**Errata for the
Atlantic Shores Offshore Wind South
Final Environmental Impact Statement**

**Bureau of Ocean Energy Management
Office of Renewable Energy Programs**

Errata Overview

**Figure 2.1-10
Alternative C4**

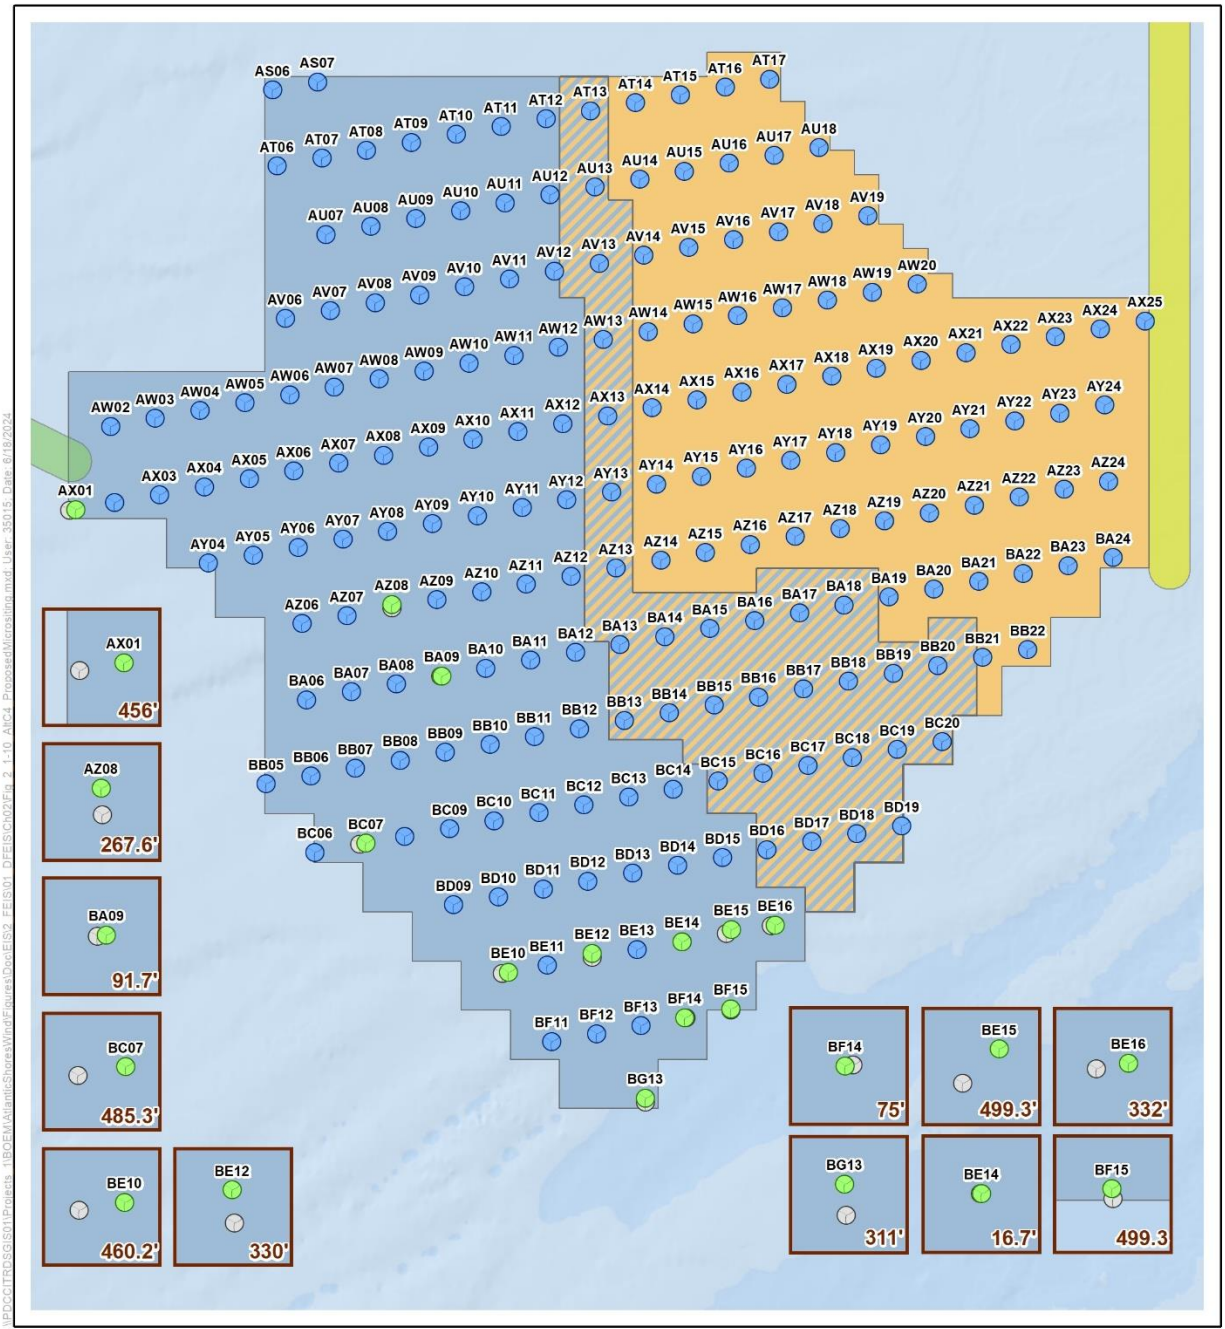
1. FEIS, Chapter 2, Page 2.27 Footnote 7; Chapter 3, Section 3.6.6.11 Page 3.6.6-34 Footnote 2

Subsequent to publication of the FEIS, the lessee submitted proposed micrositing to relocate 20 WTGs outside of the 1,000-foot (305-meter) buffer of the ridge and swale features within both AOC1 and AOC 2. BOEM and the U.S. Coast Guard reviewed the proposed micrositing and 12 of the 20 WTGs were deemed acceptable to microsite. Footnotes in the FEIS stated that no micrositied permanent structures would be placed in a way that narrows any linear rows and columns to fewer than 0.6 nautical mile (nm) by 1.0 nm. This footnote has been corrected to specify the locations for which the micrositing of WTGs would reduce the spacing between permanent structures to less than 0.6 nm or less than 1.0 nm.

Micrositing ~~would-should~~ not materially change the grid layout. No micrositied permanent structures ~~would-shall~~ be placed in a way that narrows any linear rows and columns to fewer than 0.6 nautical mile (1.1 kilometers) by 1.0 nautical mile (1.9 kilometers), with the exception of WTGs AX01, AZ08, BA09, BC07, BE10, BE12, BE14, BE15, BE16, BF14, BF15, BG13 as shown in Figure 2.1-10-C4, or in a layout that eliminates two distinct lines or orientation in a grid pattern.
